IMPERIAL PARK 132kV GIS SUBSTATION

LANDSCAPE AND VISUAL APPRAISAL PART 1 of 6

Prepared for SSE Energy Solutions
October 2025

Table 2-2: Landscape Response to Officer Comments

Image 10-1: Schematic Illustration of the constraints to new planting.

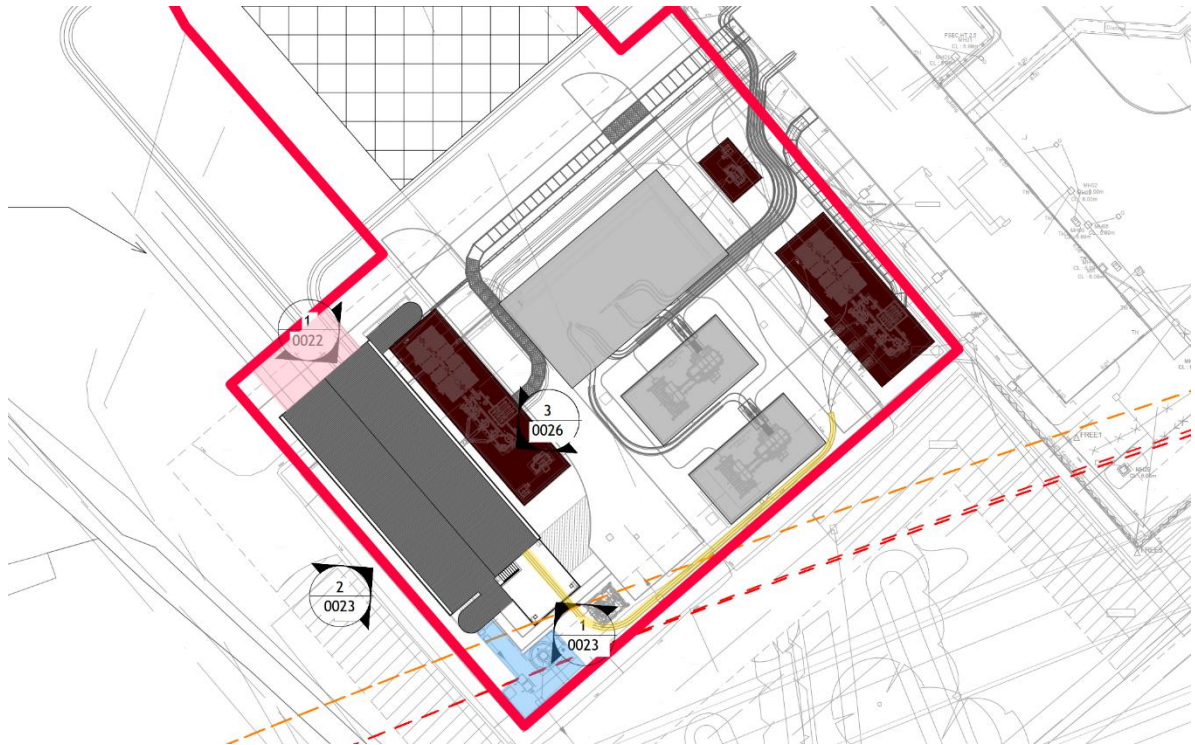
10.1 With reference to the following extract of the Site Plan, the constraints of new planting are that:

- The southern part of the Site, between the red line and the GIS building are within the high voltage overhead cable swing safety zone (illustrated via the orange and red dashed lines). National Grid¹⁶ require a minimum distances between the conductors and the ground, such that new planting to the south of the GIS building would need to be low in height

- There are several 132kV high voltage below ground cables to the north of the GIS building (illustrated via the pink hatch);
- A path will be required around the perimeter of the GIS building for maintenance access, negating the ability to plant adjacent to the building, including along the western façade, due to the 2m between the building and the new electric fence;

- Below ground cables extend between the existing and proposed equipment, with operational requirements needing this areas to be accessible; and
- Future below ground cable routes will be required, which will be subject to new planning applications, thereby requiring areas around the building to be accessible.

- 10.2 Due to the constraints, it is considered that new planting is not practicable in proximity to GIS building to enable any effective visual screening of the GIS building.
- 10.3 The effects of the Proposed Development are therefore considered to remain as stated in the previous chapter.

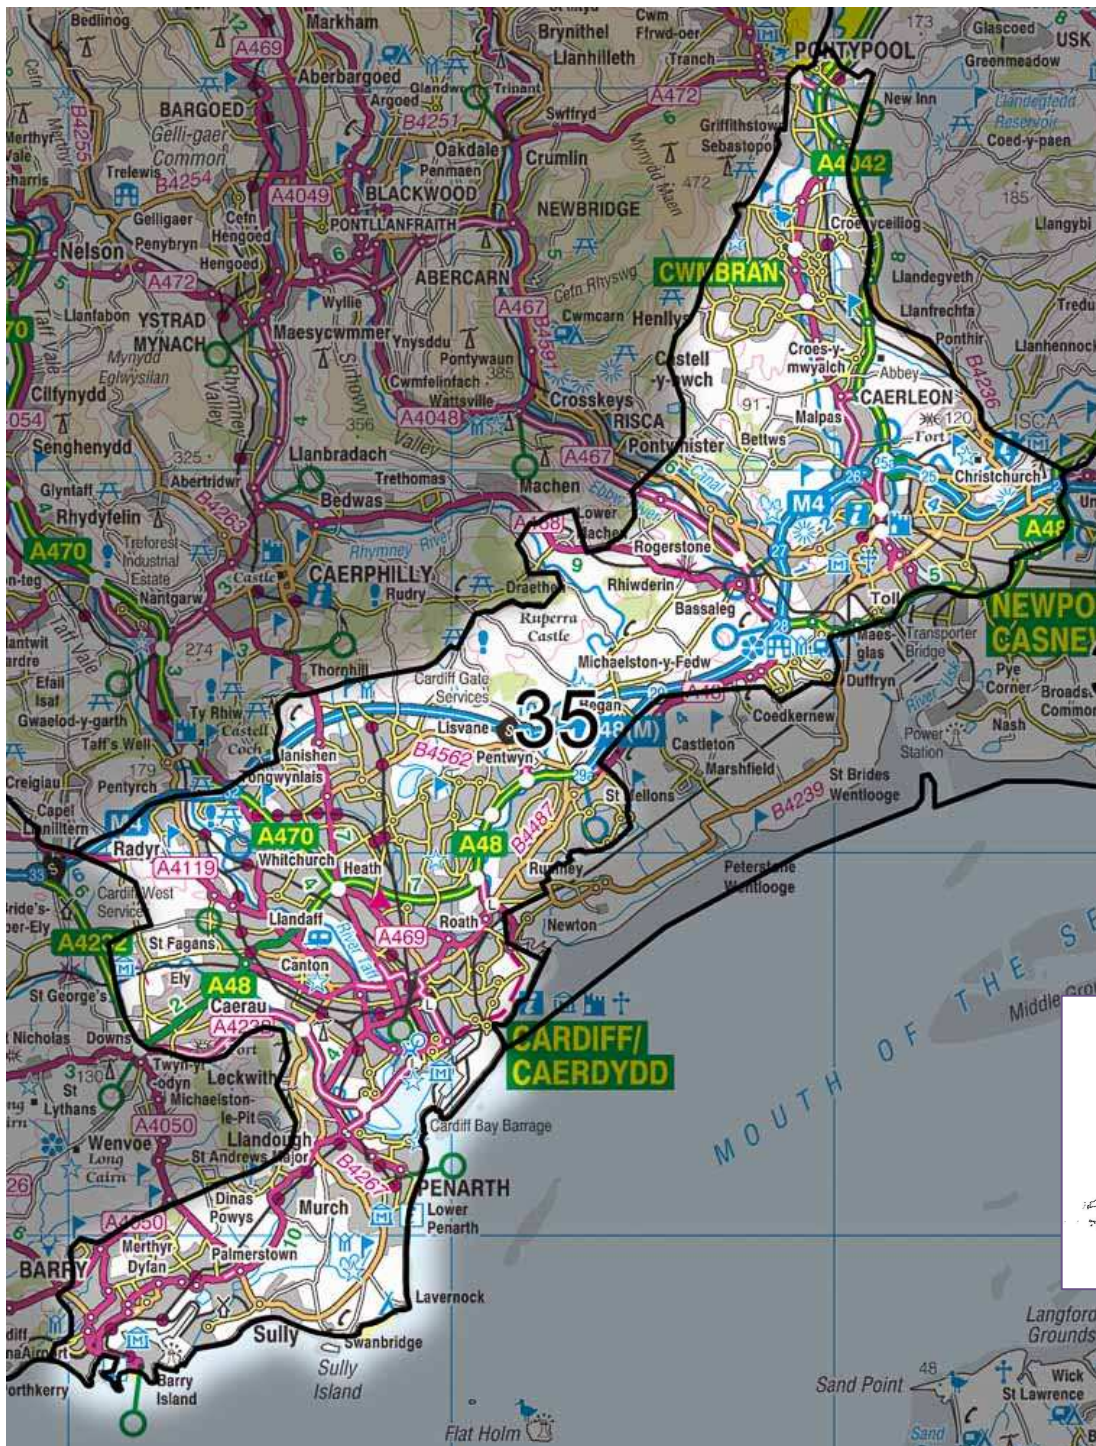
The site lies within the Wentlooge Special Landscape Area and Green Wedge however there is no mention of how these policies have been applied.

There is no review of the amenity impact on users of the Percoed Reen cycleway which lies 50m to the south. The building height at 19m will have a reasonably large view-shed in the flat landscape and will require mitigation. New planting may be required outside the red line but within the landownership boundary.

There is no replacement planting to mitigate for tree/scrub losses outlined in the Arboricultural Impact Assessment.

There is no enhancement planting to meet LDP GP5: vi the proposal includes an appropriate landscape scheme which enhances the site and the wider context including green infrastructure and biodiversity networks.

I recommend the proposals are reviewed by a professional landscape architect. The following is required at full planning :

1. Panoramic photos from both directions from the cycleway with the building mass highlighted as a simple line. The impacts should be described and appropriate mitigation shown on a plan.
2. Building on the above, a detailed planting plan (to include maintenance for the first 5 years) is required. If there are constraints to tree planting from service runs these should be clearly shown.
